ICHD - ENVIRONMENTAL HEALTH DIVISION

SEPTIC: IMPROVEMENT PERMIT / AUTHORIZATION TO CONSTRUCT / OPERATION PERMIT / EXISTING SYSTEM

APPLICANT/OWNER: Nest Homes LLC | APPLICANT ADDRESS: P.O Box 3965 Mooresville, NC 28117

SITE ADDRESS: 185 Ponderosa Circle Mooresville, NC 28117 | PHONE: 980500 1239 | ALT. PHONE

INITIAL SITE SKETCH

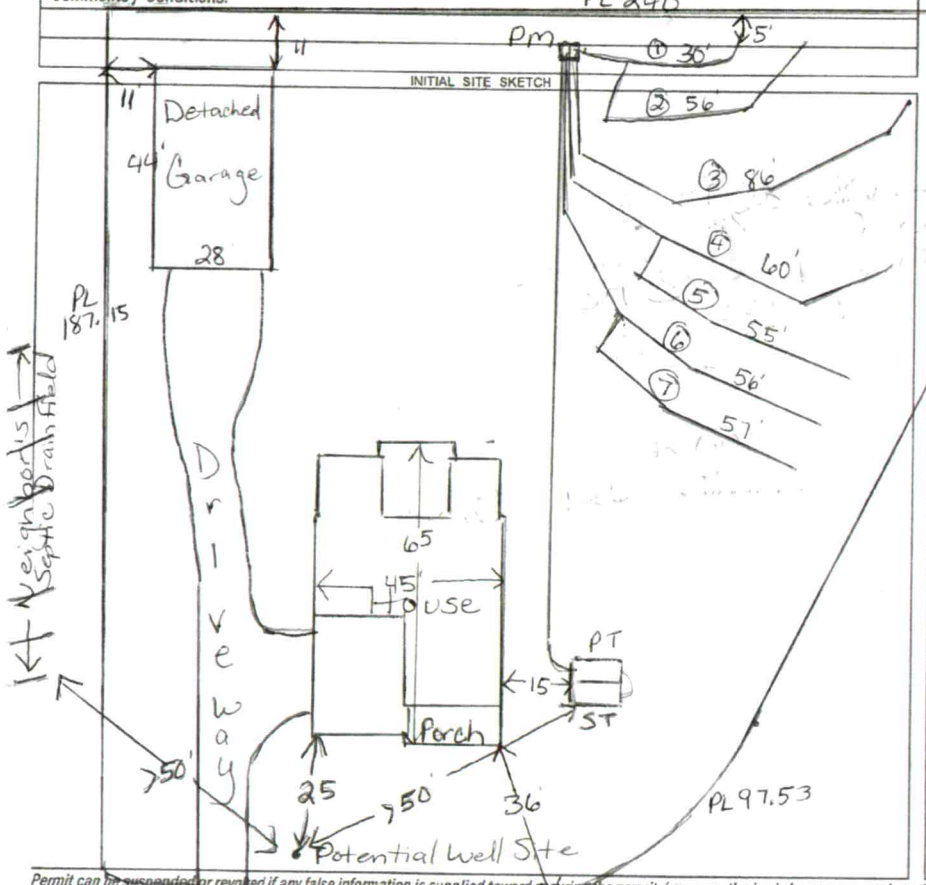
Relocate power/utility line 15ft from Septic System. Septic must be 50ft from Well * Floor plans show 3 Bedrooms permit is for 4 Bedrooms

INITIAL SITE SKETCH

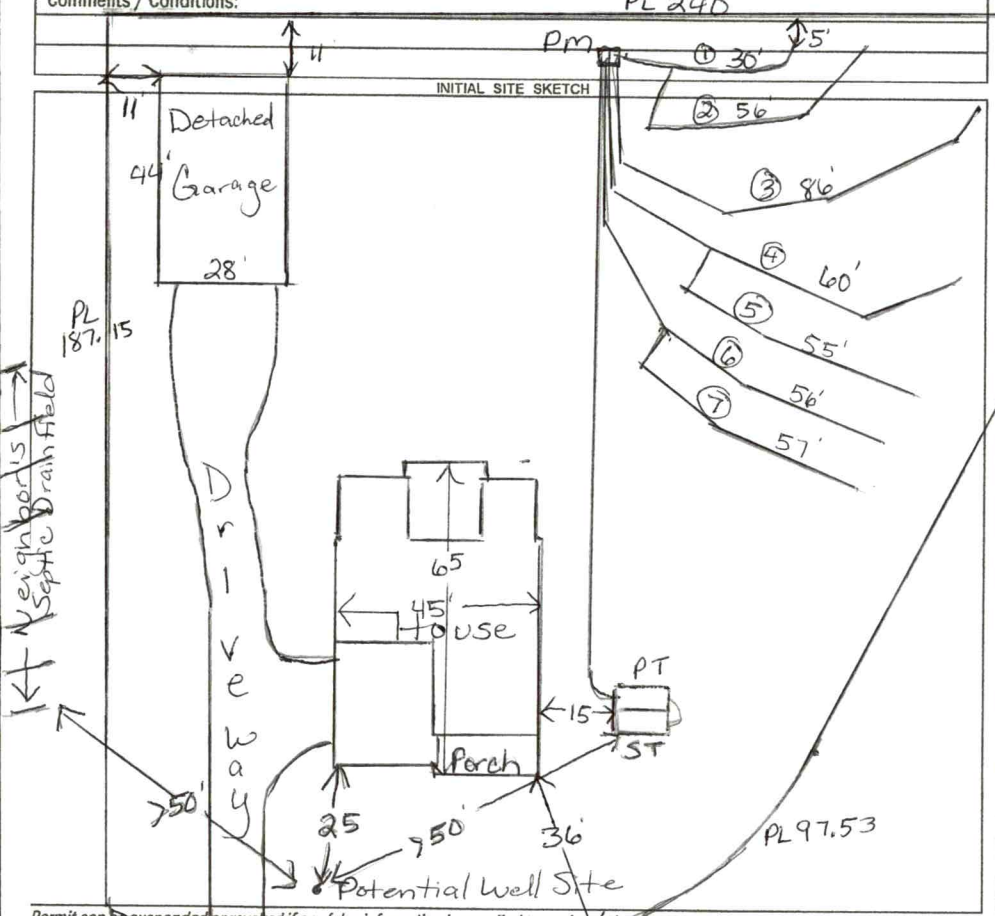
Relocate power/utility line 15ft from Septic System. Septic must be 50ft from Well * Floor plans show 3 Bedrooms, permit is for 4 Bedrooms
